ADDENDUM No. 03

Subject: Wright Elementary School – Major HVAC Renovation
SDP Contract No.

This ADDENDUM dated 1/26/2022 shall modify and become part of the Contract Documents for the work of this project. Any items not mentioned herein, or affected by, shall be performed strictly in accordance with the original documents, unless modified by prior addenda, if any.

EL104

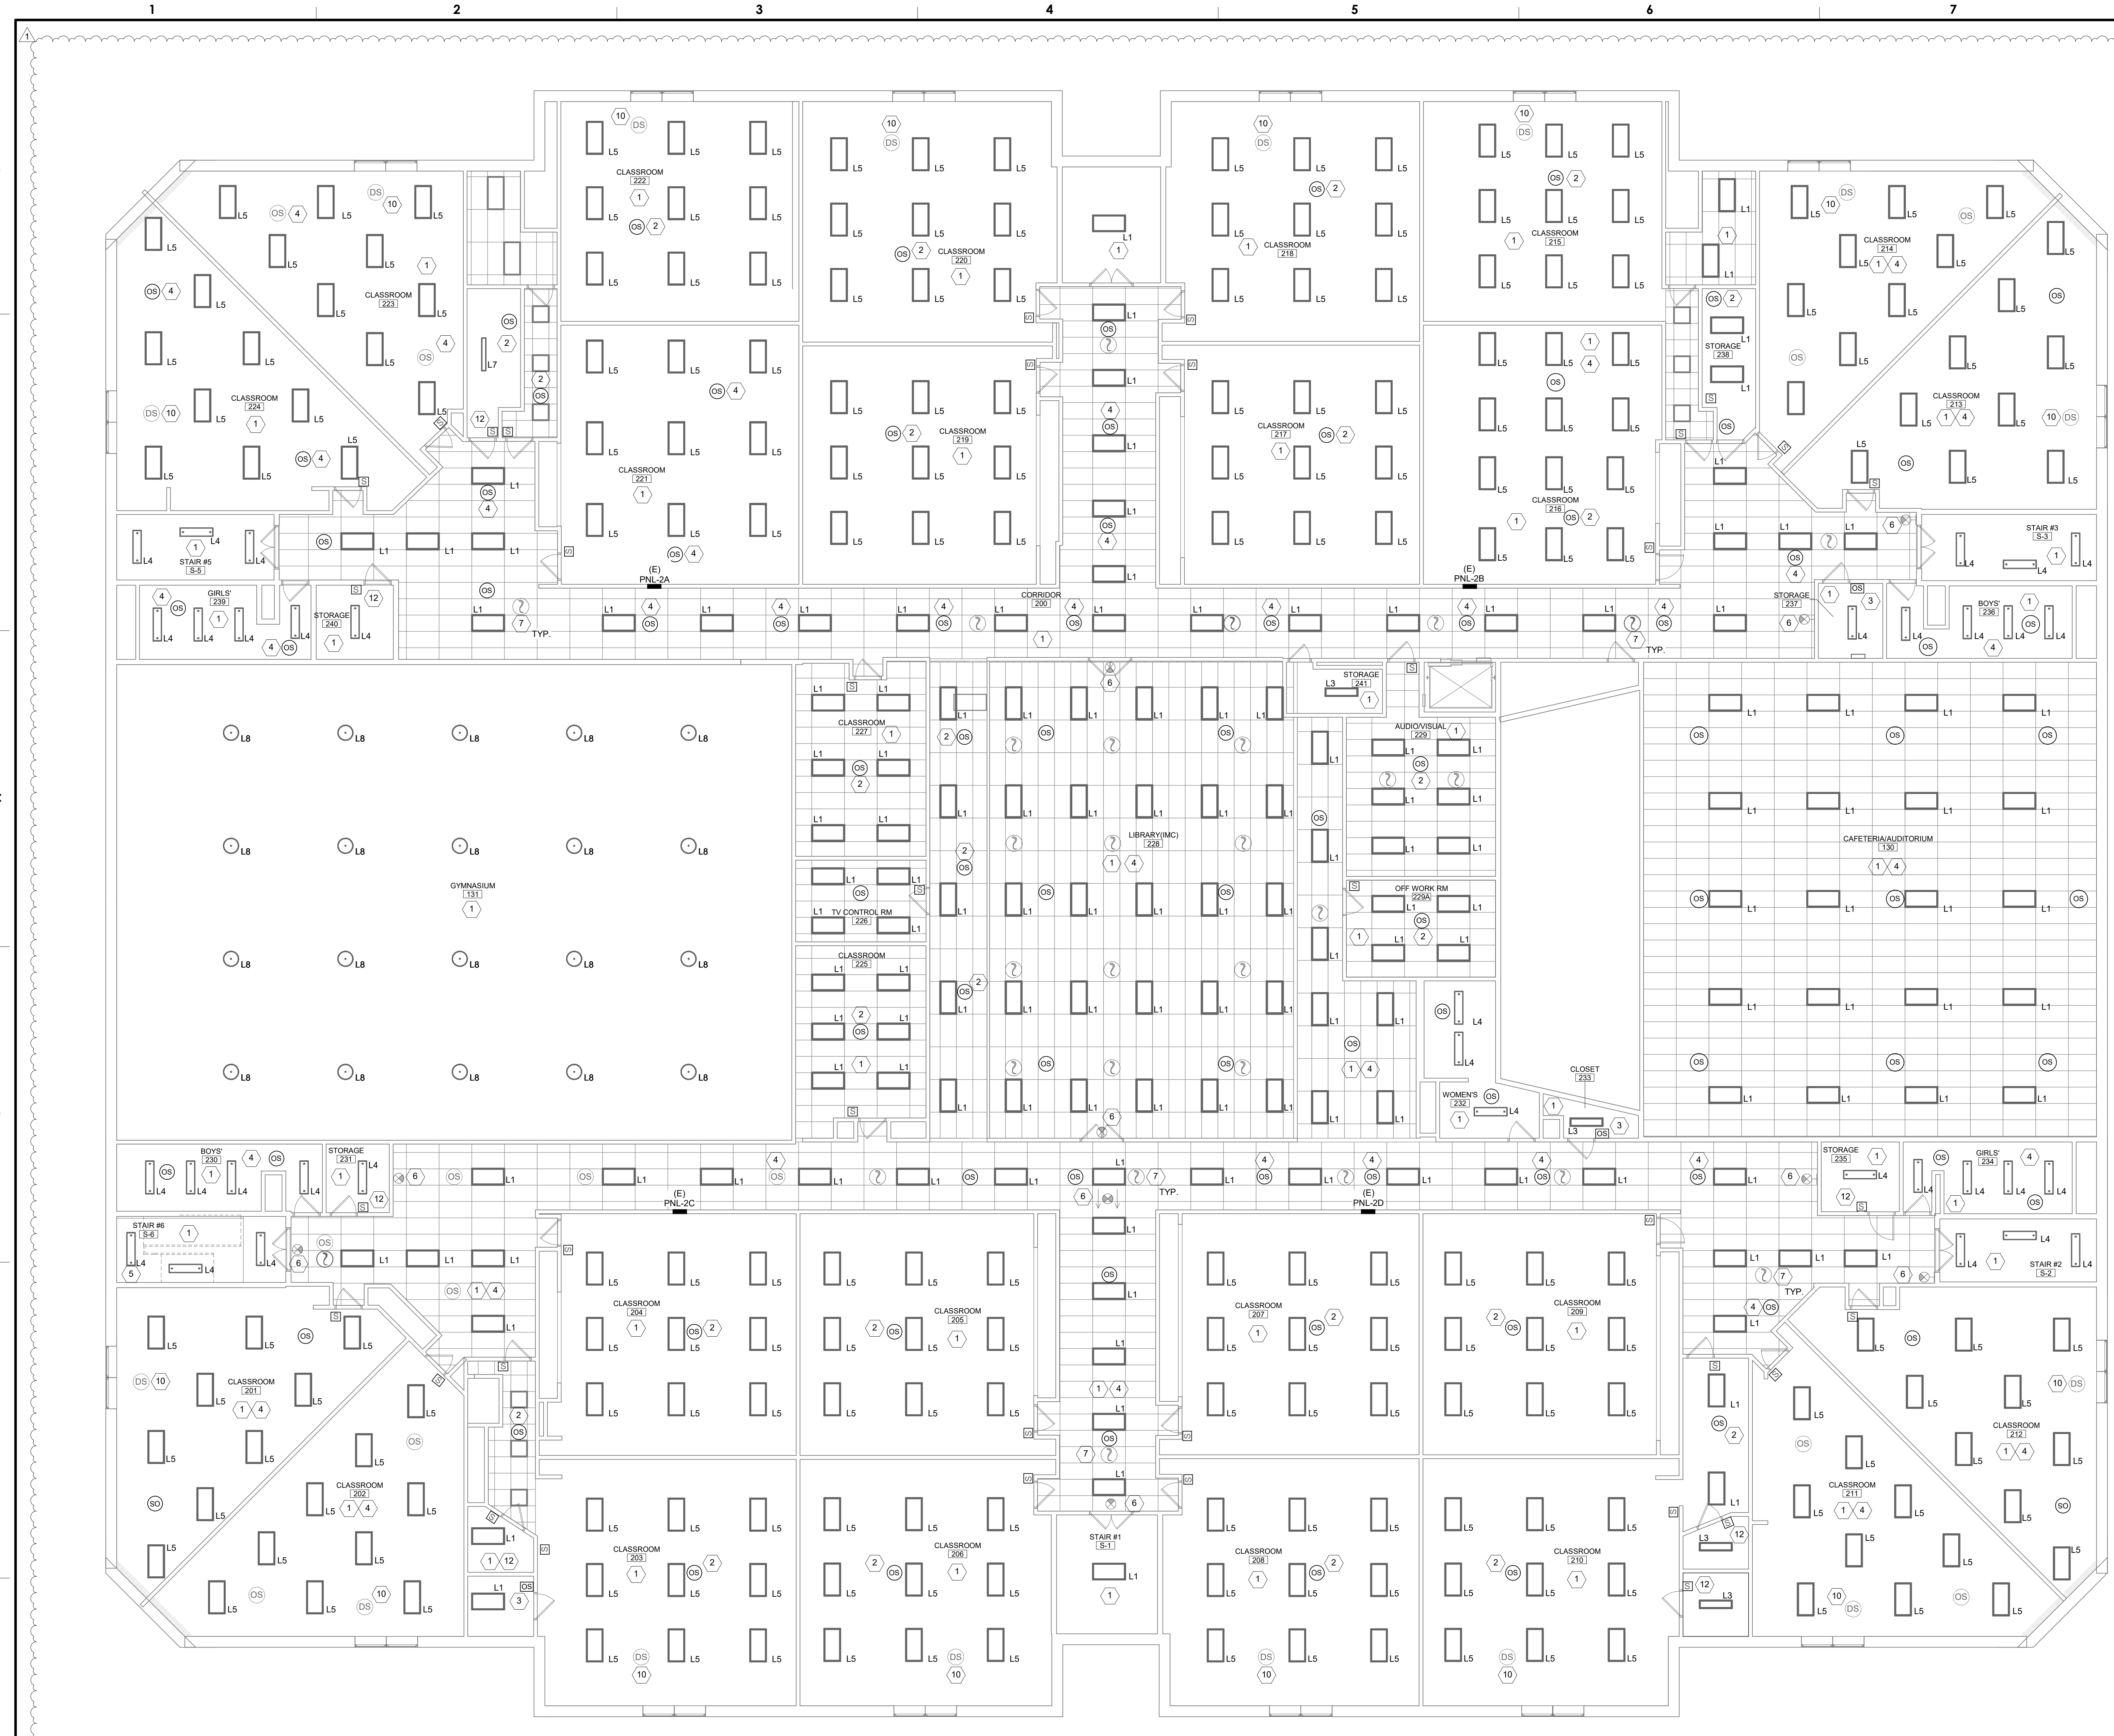
- a) Are we purchasing new light fixtures for these areas
- b) Can you provide a lighting drawing with locations?
- c) Can you provide a model number and any required controls?

Electrical note 5 on Plans E102 & E103 notes that all Light Fixtures in given rooms will be removed and reinstalled in new drop ceiling. However, when referencing the Architectural RCPs A103 & A104, these notes indicate that the some of the 2x4 lay in fixtures and exit signs are to be replaced with new. Which is correct?

Lighting scope has been amended per new EL Drawings. Electrical Contractor shall remove all existing and provide all new lighting fixtures throughout the building. See attached EL Drawings for new general lighting scope.

- Exit Signage scope to remain defined on E101.
8. E102
- DELETE references to general lighting scope. This scope has been defined on new drawing EL104.
